Model: Model U-P1		Date: 19-Dec-02	No.: MG071001
Modified Article: Parts Catalogue		Prepared by: H.K.	
From: Technical Services sec. Service Planning Dept.			
Reason for Modification:	<input checked="" type="checkbox"/> Parts catalog correction	<input type="checkbox"/> Vendor change	<input type="checkbox"/> To meet standards ()
	<input type="checkbox"/> To facilitate assembly	<input type="checkbox"/> To improve reliability	
	<input type="checkbox"/> Part standardization	<input type="checkbox"/> Other

Model: Model U-P1	Date: 27-Dec-02	No.: MG071002
-------------------	-----------------	---------------

Modified Article: Development unit - MYC		Prepared by: H.K.	
From: Technical Services Sec. Service Planning Dept.			
Reason for Modification:	<input type="checkbox"/> Parts catalog correction	<input checked="" type="checkbox"/> Vendor change	<input type="checkbox"/> To meet standards ()
	<input type="checkbox"/> To facilitate assembly	<input type="checkbox"/> To improve reliability	
	<input type="checkbox"/> Part standardization	<input type="checkbox"/> Other

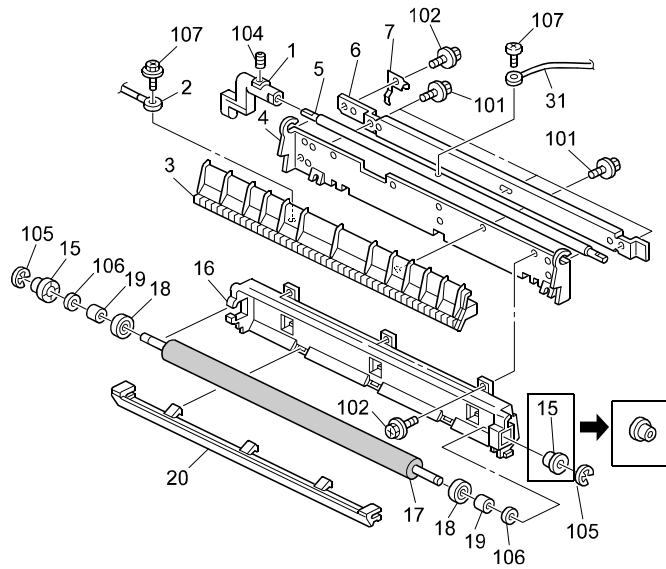
Due to a vendor change, the P/N for the M, C and Y Development Units have been changed.

Old part number	New part number	Description	Q'ty	Int	Page	Index	Note
G0703501	G7823025	Development Unit - M Ass'y	1	O/O	27	22	
G0703502	G7823026	Development Unit - Y Ass'y	1	O/O	27	20	
G0703503	G7823027	Development Unit - C Ass'y	1	O/O	27	21

Fig. 1

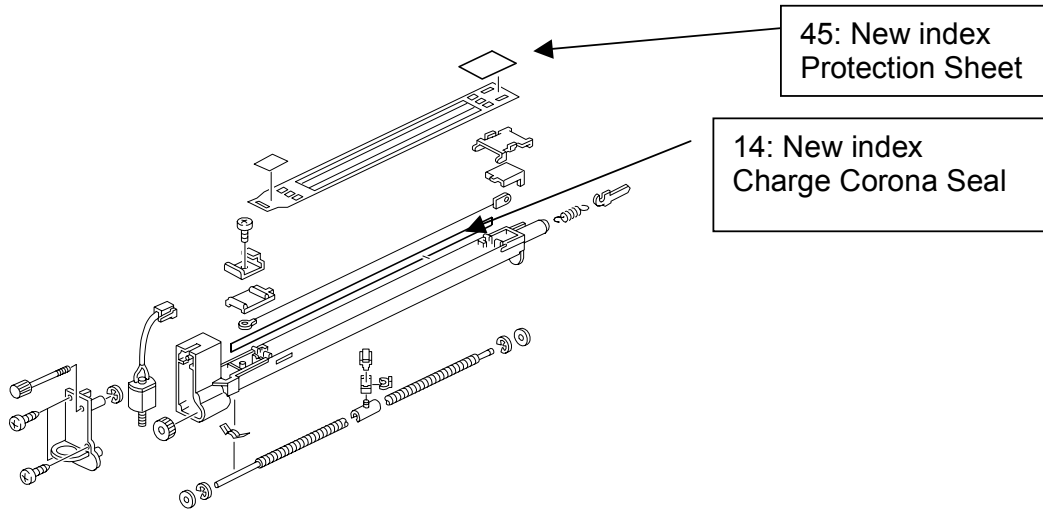
- The material of the charge corona seal has been changed to reduce the friction between the seal and OPC belt.

Note: The charge corona seal is not included in the P/C illustration on pg. 24, so please apply the correction shown below in Fig. 1. Also, the old part number is not listed on pg. 25, so please add the new part number and index number listed above to this list.

- To reduce the possibility of damaging the OPC belt when the charge corona unit is removed from and installed into the PCU, a protection sheet has been added to the rear end of the charge corona grid (see Fig.1).

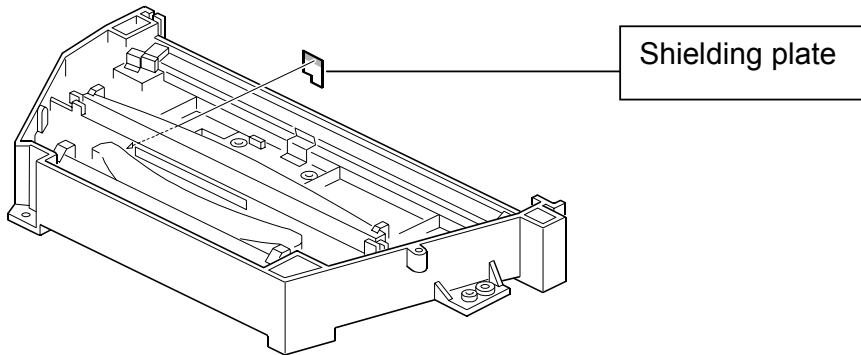
To improve image quality, a Shielding Plate has been added for filtering out excessive light.

Old part number	New part number	Description	Q'ty	Int	Page	Index	Note
	B0511969	Shielding Plate	1		23	*22

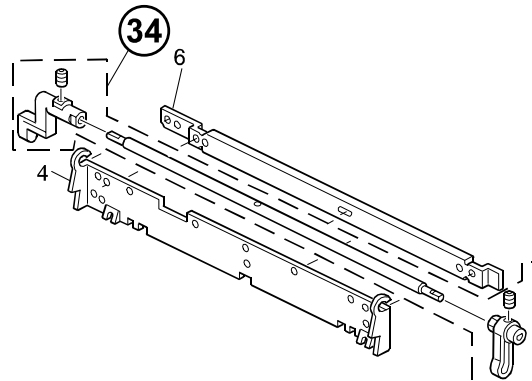
The Front Arm, Rear Arm and Arm Shaft have been combined into one assembly to ensure that the shaft is level when attached, because this is difficult to achieve when installing the individual components without a factory tool.

Old part number	New part number	Description	Q'ty	Int	Page	Index	Note
G0706238		Front Arm	1-0		21	10	
G0706239		Rear Arm	1-0		21	1	
G0706240		Arm Shaft	1-0		21	5	
05730040E		Hexagon Headless Set Screw – M3x4	2-0		21	104	
	→ G0706237	Arm Shaft Assembly	0-1		21	34

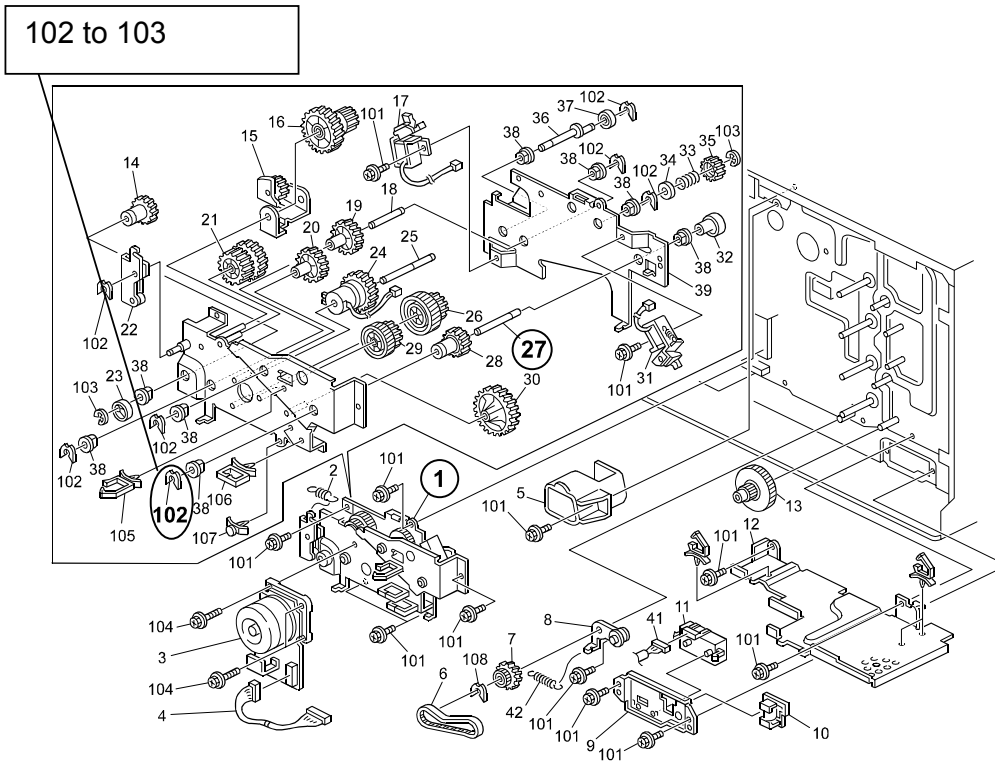
The following have been changed to further ensure proper function of the cam (G0704829) by minimizing the possibility of an excessive load placed on the cam.

Note: When installing for the first time, parts (AA145563) and E-ring marked index 102 should be changed together **as a set**.

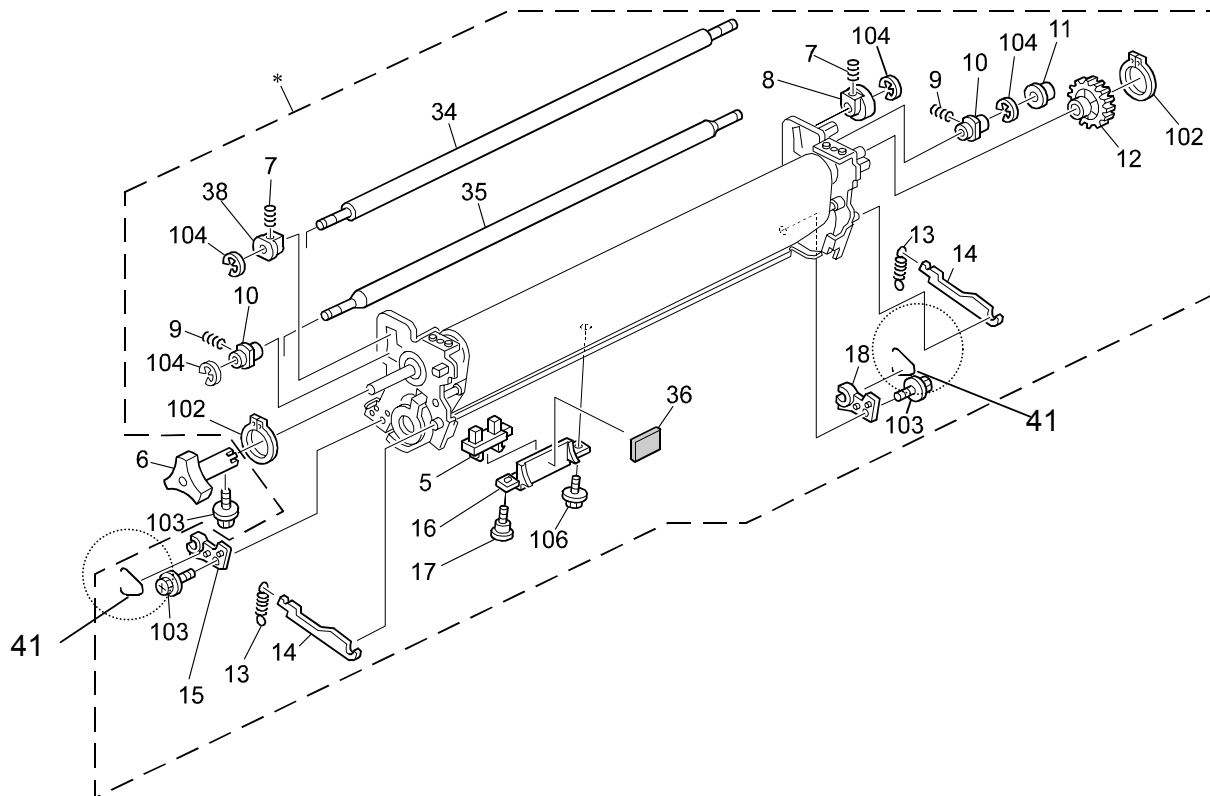
Please add the following information, which was previously missing from the Parts Catalog.

Old part number	New part number	Description	Q'ty	Int	Page	Index	Note
	G0704153	Stopper Spring	2		30	41

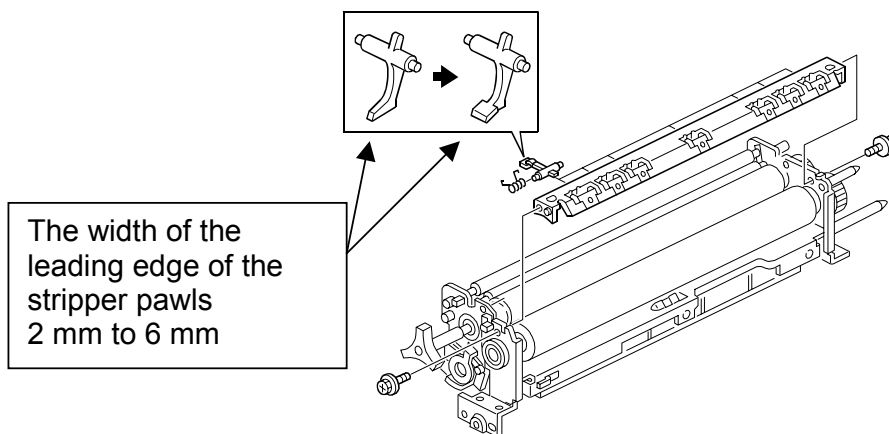
The width of the leading edge of the stripper pawls has been changed from 2 mm to 6 mm. The angle for the pawls has also been changed.

Due to this modification, the stripper pawl springs also have been changed.

Incorrect part number	Correct part number	Description	Q'ty	Int	Page	Index	Note
G0704004	G0704010	Pick-off Pawl Assembly	1-1	X/O	29	1	
AE044041	AE044050	Stripper Pawl	7-7	X/X	29	6	*
AA069261	AA069263	Stripper Pawl Spring	7-7	X/X	29	13	*

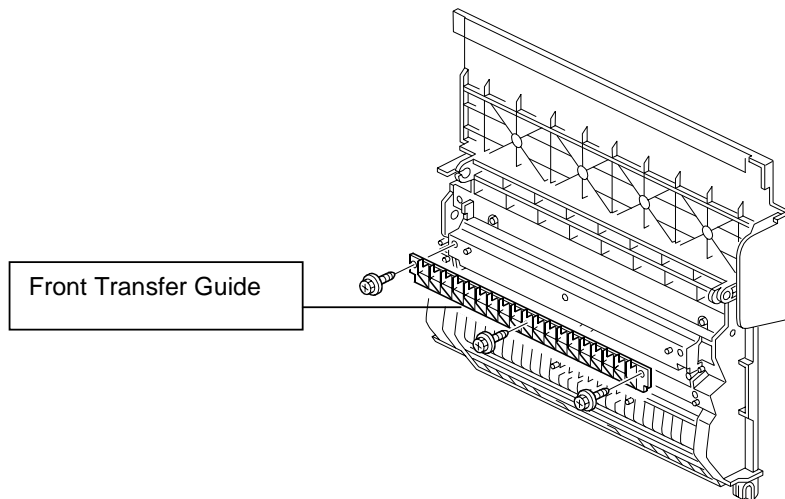
The Front Transfer Guide was added as it was previously missing from the Parts Catalogue.

Incorrect part number	Correct part number	Description	Q'ty	Int	Page	Index	Note
	B0511365	Front Transfer Guide	0 - 1		21	*33

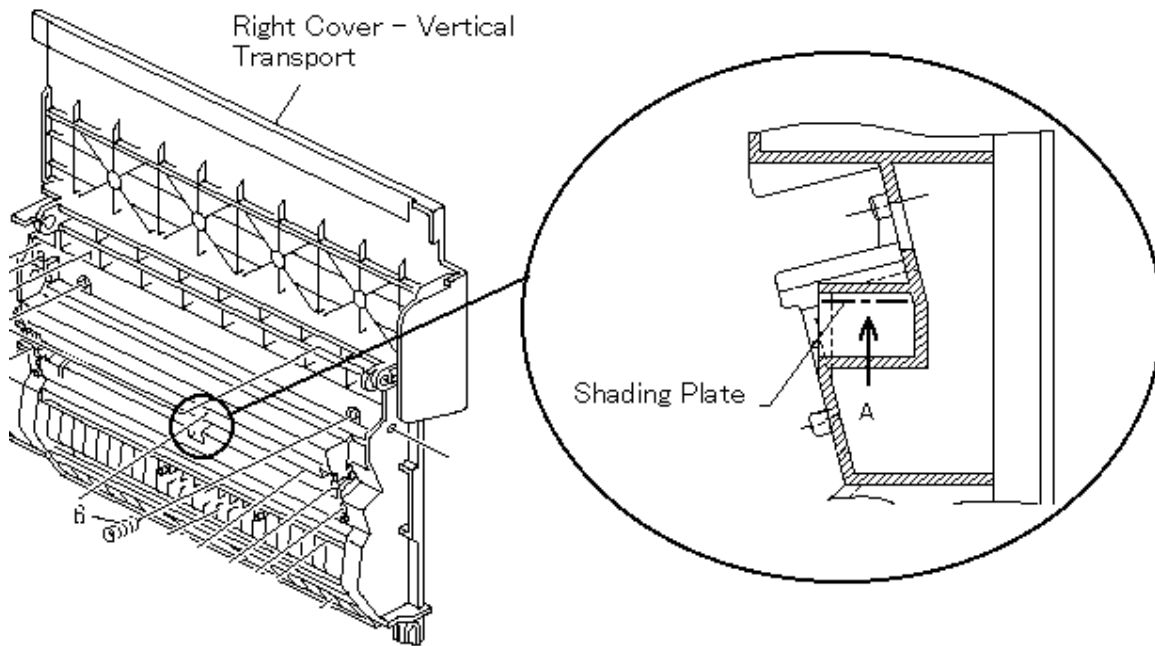
A black shading plate has been added to the vertical transport right cover, which will further ensure proper paper feed by preventing registration sensor misdetections caused by light diffused by paper dust.

Old part number	New part number	Description	Q'ty	Int	Page	Index	Note
	G0702136	Grid Shading Plate	0 - 1		21	*34

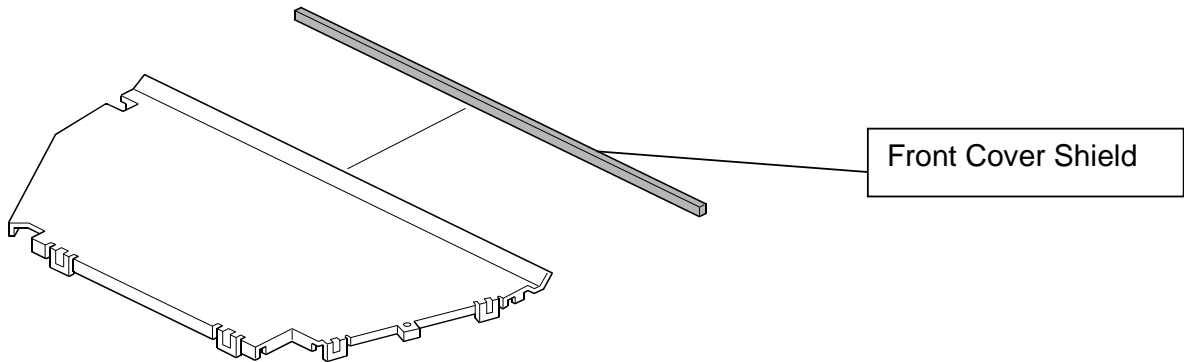
The following is the correct illustration for the front cover shield (P/N G0701942, pg. 23, index #2).

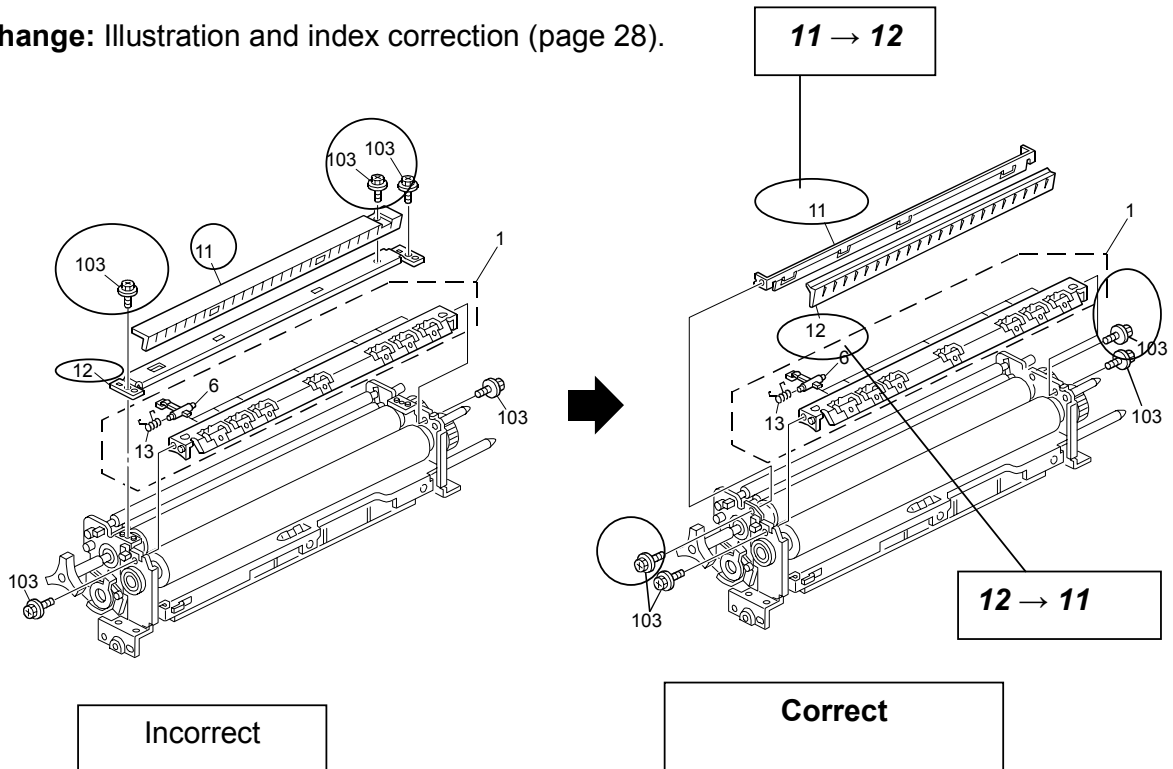
Change: Illustration and index correction (page 28).

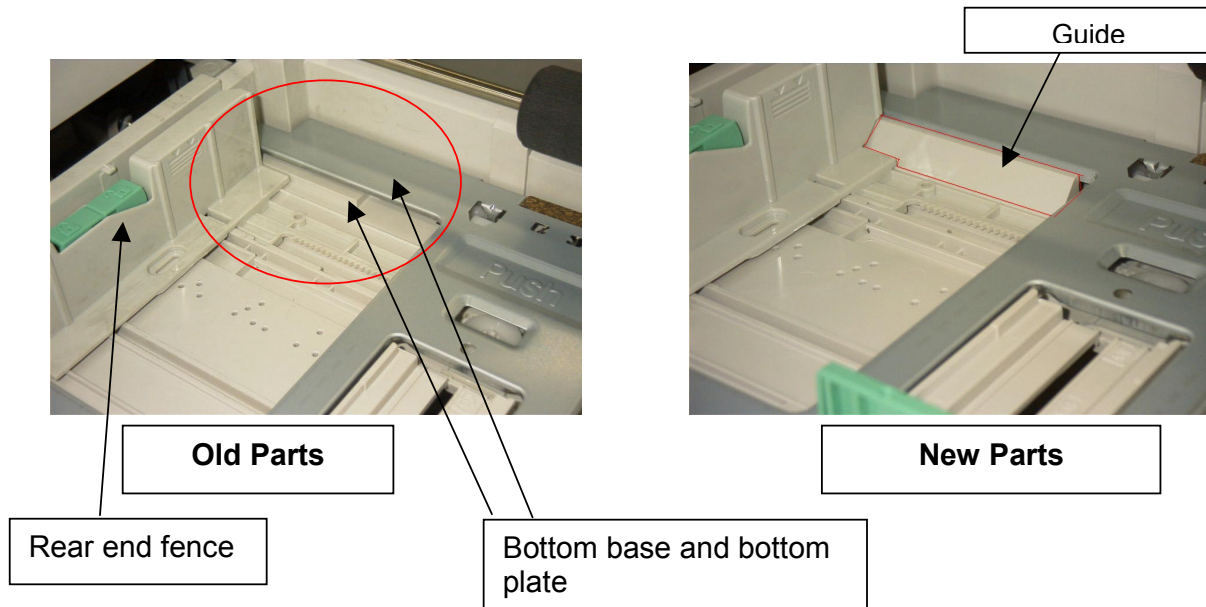
- 1) Two guides were added to the bottom base of the paper tray
- 2) The shape of the side fences was changed

Reason: To make it easier to load the paper in the tray. This ensures that paper does not get caught in the gap between the bottom base and bottom plate.

Important: If the old side fence needs to be replaced, install the new paper tray (B0512711).
